ADDENDUM # 2

Title: Wetland Restoration and Repaving of Parking Lot "U" – Rhode Island College

ADDENDUM TO PLANS AND SPECIFICATIONS

REVISED PLAN: ADDITIONAL Storm-Drain Improvement Requirements

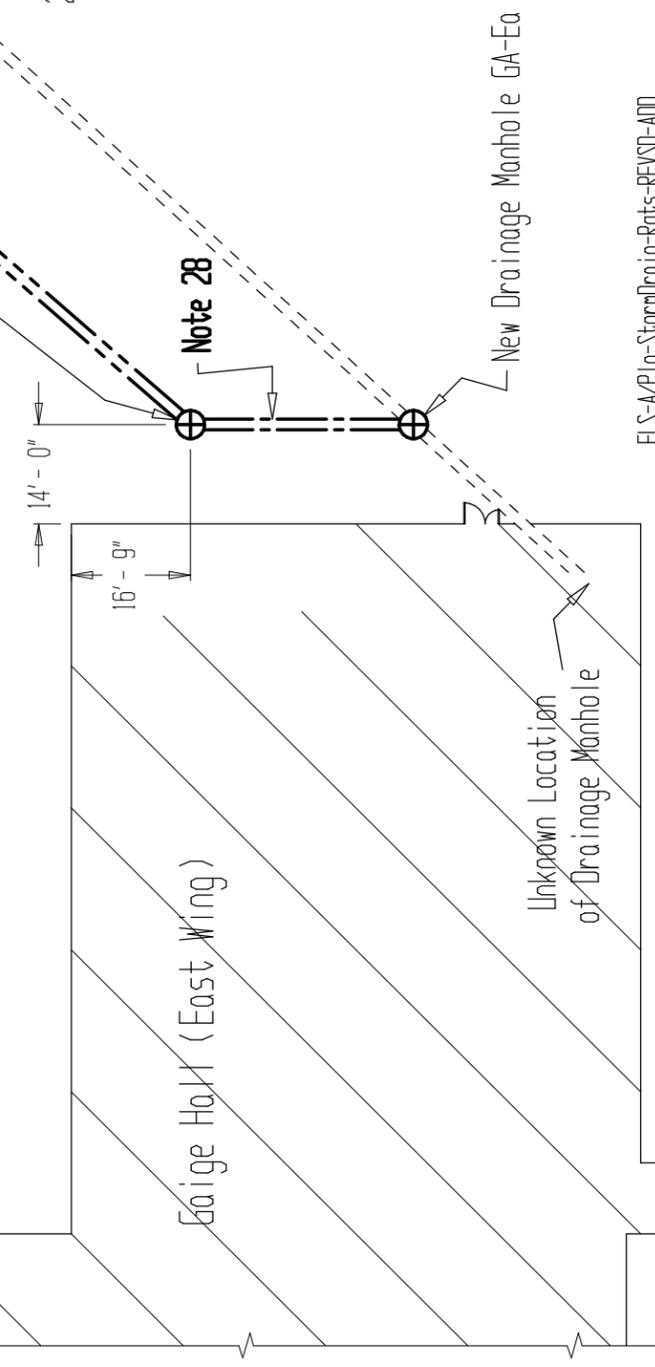
- 25. This is the Existing 15" D R-C Discharge Pipe that Conveys Storm Water from Drainage Manhole# AL-NW to Drainage Manhole# AL-We. The Rim Elevation of the Drainage Manhole# AL-NW is about 163.51' & the Invert of the Existing 15" D R-C Discharge Pipe is about 153.7'. The Rim Elevation of the Drainage Manhole# AL-We is about 160.0' & the Invert of Its Existing 18" D R-C Discharge Pipe is about 153.0'.
- 26. This is the Existing 18" D R-C Discharge Pipe that Conveys Storm Water from Drainage Manhole# AL-We to a Drainage Manhole that we Cannot Locate. From Drainage Manhole# AL-We, we were Only Able to Send the Underground-Pipe Video Camera 91' into this Existing 18" D Pipe of Note 24. Based on Signals from this Camera, we ESTIMATE that this 18" D R-C Pipe Passes under Gauge Hall at a Location about 27' South of the Building's NE Corner.

- 27. ADD ALTERNATE ONE: Indicate the Additional Costs (to be Added to the BASE BID Price) which Apply when the College Directs the Contractor to: A. Excavate & Locate that Segment of the 18" D R-C Storm-Drain Pipe of Note 26 that is Installed Below the Improved Grounds Located between the East Wall of Gauge Hall & the West Edge of the N-S Sidewalk. B. F&I a New 5'-0" D R-C Drainage Manhole# GA-Ea within the Planting Bed East of Gauge-Hall; the Manhole is to be Centered on the 18" D Drain Pipe's Centerline & is to Sever this Pipe (Removing 5' to 6' of Pipe). Retain this Pipe's Existing Inverts & have this Pipe pass through Pre-Cast Holes in the Manhole's Bottom Segment. Due to these Invert Elevations, the Base of this Drainage Manhole will be at an Elevation of about 10' or 11' Below Grade. C. Excavate around the South & West Sides of Drainage Manhole # AL-NW. Remove Sufficient Length of the Note 25 Pipe; Enlarge the Manhole's Discharge-Pipe Hole to 18" D while Retaining the SAME INVERT Elevation; & F&I about 235' of 18" D R-C Discharge Pipe to Convey Storm Water from Drainage Manhole# AL-NW to Drainage Manhole# GA-Ea (where this Pipe's Invert Elevation shall MATCH the Invert Elevation of the Existing Note 26 Pipe). This 18" D Note 27 Drain Pipe will be Crossing Under One High-Voltage Conduit System (probably Concrete-Encosed)...CONTINUED on REVISED PLAN: ADDITIONAL Storm-Drain Improvements Requirements.

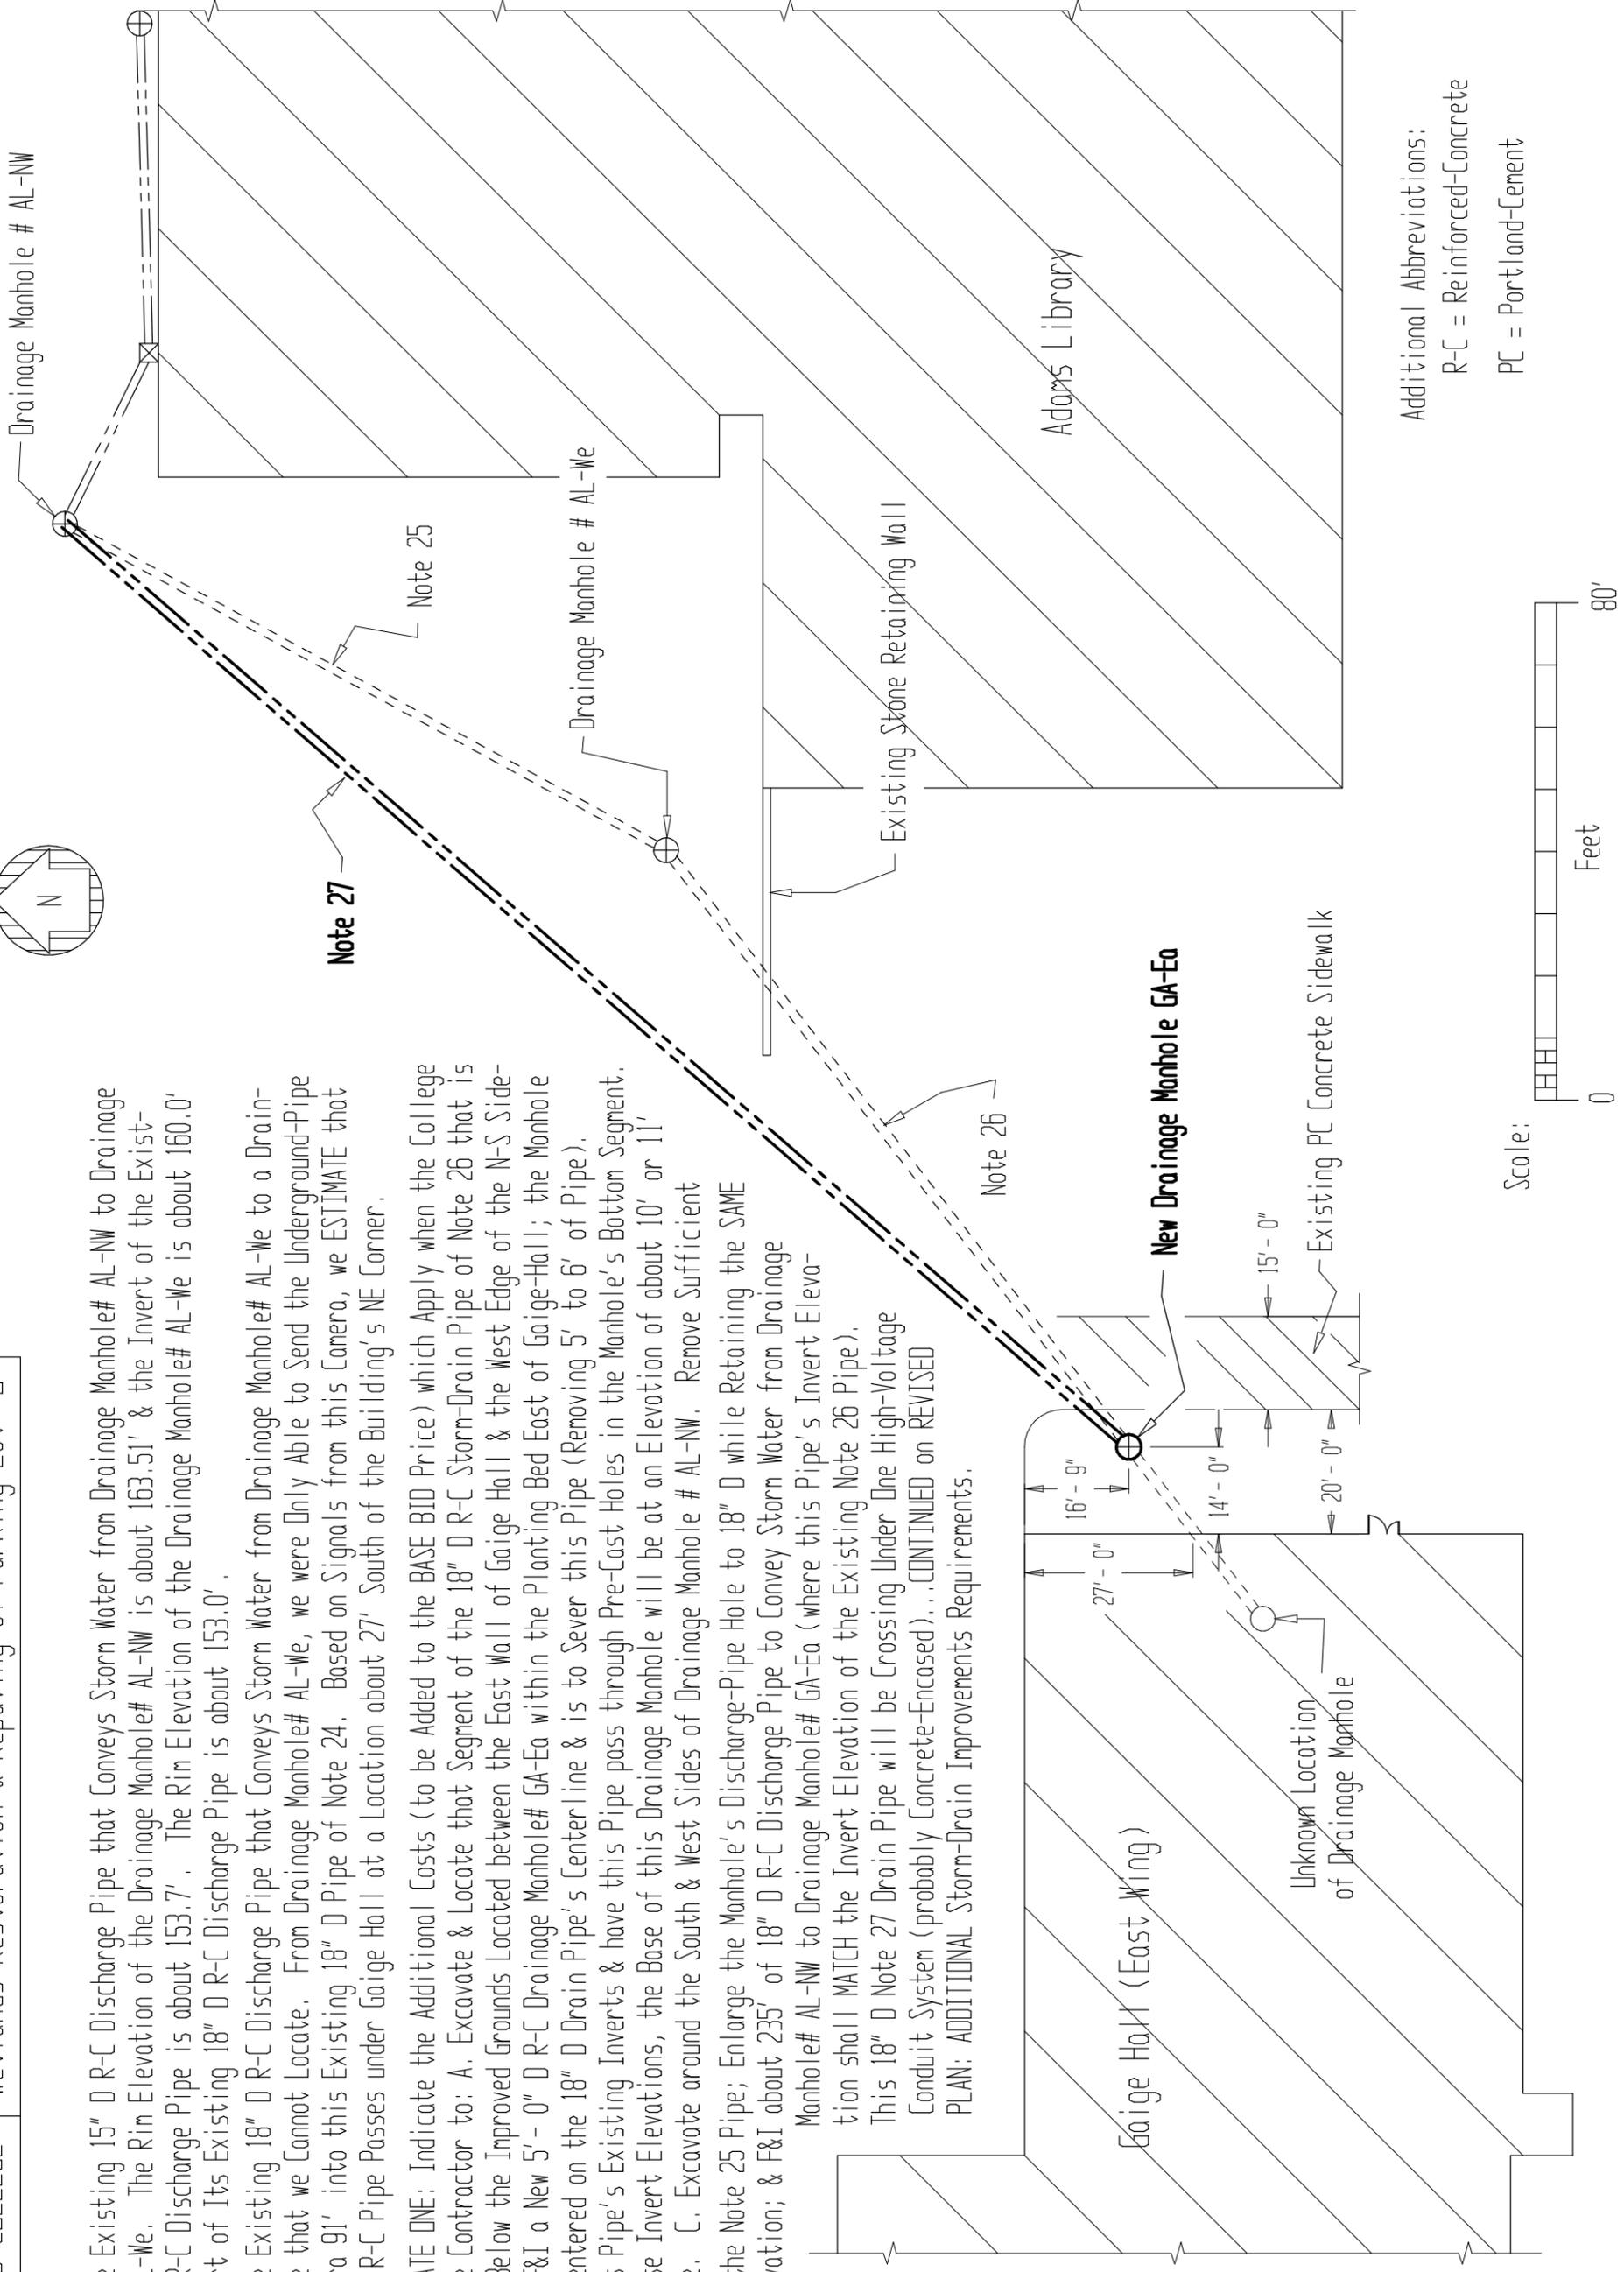
27. CONTINUED...Crossing Under One H-V Conduit System (probably Concrete-Encased) & Under TWD 8" D Clay-Tile Sanitary Sewer Lines. Be Cautious, while Excavating for Manhole# GA-Ea, NOT to Damage a Roof-Drain Pipe & a Natural-Gas Pipe which Exist Parallel to Gaige Hall's East Wall. Based on this Location for MH# GA-Ea, the Note 27 Excavation will Pass West of the Stone Wall & Higher-Elevation Grounds. D. F&I All Code-Required Shoring to Preclude Ditch-Collapses. About 40 Linear Feet of this Excavation will Cut Through PC Concrete Sidewalk; Most of the Remaining Excavation will Cut through Asphalt Parking-Lot Pavement (Saw-Cut All Edges of Pavements being Cut). E. F&I & COMPACT 6" Thick Washed Sand Bedding Below, on BOTH Sides & Above to Completely Surround All Storm-Drain Pipe being F&I. F. Before Backfilling South of Manhole# AL-NW, Cap & Seal the North End of the Note 25 Pipe so that Water will NO Longer Flow through this Pipe & into Manhole# AL-We. G. Properly Seal around the Openings (Both Inside & Outside the M-H) of All Pipes Entering or Discharging the Storm-Drain Manholes# AL-NW & GA-Ea. H. Backfill, Compact the Soils being Backfilled; F&I a 6" Compacted Layer of Specified Base Course Material at the Surface of the Backfill & below the Replacement Pavement. F&I Asphalt & PC Pavement to Replace any Pavements Removed during Excavations for R-C Storm-Drain Pipes of this Contract; Match Existing Pavement Thicknesses; Comply with All Applicable Paving Requirements in the Original Specifications & with those in the ADDENDUM. REPLACE Any of the Replacement Pavements that Settled (more than 1/4") within 12 Months of their Installation.

28. ADD ALTERNATE TWD (will ONLY be Accomplished if ADD ALTERNATE ONE is Already Approved, Directed & Funded): Indicate the Additional Costs (to be Added to TOTAL of the BASE BID Plus the ADD ALTERNATE ONE Prices) which Apply IF the College (Because the Existing Note 26 R-C Pipe is LOCATED TOO FAR SOUTH - as shown on this PLAN) Directs the Contractor to: A.

28. ADD ALTERNATE TWD (CONTINUED)...Directs the Contractor to: A. F&I a Second Manhole# GA-2 at the approximate Location Shown on this PLAN that has 18" D Pre-Cast Openings in Its Bottom Segment at NorthEast & South Directions; Comply with All Applicable Requirements of Note 27 (such as Cautious Excavating, Sealing of Pipe Openings). (Manhole GA-Ea will have been F&I per Note 27 but Farther to the South, about as Shown on this PLAN.) (The 18" D R-C Drain Pipe of Note 27 will have Already been F&I per that Note; but with Its Invert Elevation Slightly Higher - than Projected in Note 27 - as It Enters GA-2 through the NorthEast Opening.) B. F&I about 50' of 18" D R-C Storm-Drain Pipe to Convey Storm Water from Drainage Manhole# GA-2 & through a North Pre-Cast Opening into Drainage Manhole# GA-Ea (where this Pipe's Invert Elevation shall MATCH the Invert Elevation of the Existing Note 26 Pipe).

C. Comply with All Applicable Requirements of Note 27 (such as Shoring of Excavations, Pipe Bedding & Backfilling, Pavement Repairs). For Grounds Repair, Comply with Note 7E, Note 7E (ADDED) & the Specifications.

29. GENERAL: All Asphalt-Concrete Paving & Patching of this Contract is to be Performed ONLY on a Dry Base Course, in DRY Weather & when the Temperature is Above 40° F & Rising.

Second Drainage Manhole GA-2
